Access Compliance Report

Public Rights-of-Way

(Curb Ramps)

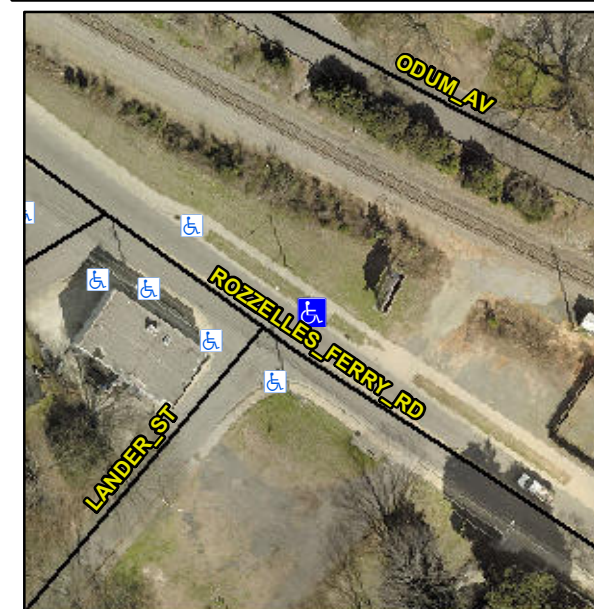
Intersection ID: 8722	Main Street: LANDER_ST	Cross Street: ROZZELLES_FERRY_RD	Location:	N
ADA ID: 4C499D14B284	Ramp Type: Perp	Initial Pass/Fail: Fail	Overall Compliance: No	Severity Score: 8.75
Codes/Mitigation Info/Possible Solution		Field Measurements/Component Compliance

Not Found, R304.5.1

Remove & Replace Entire Ramp.
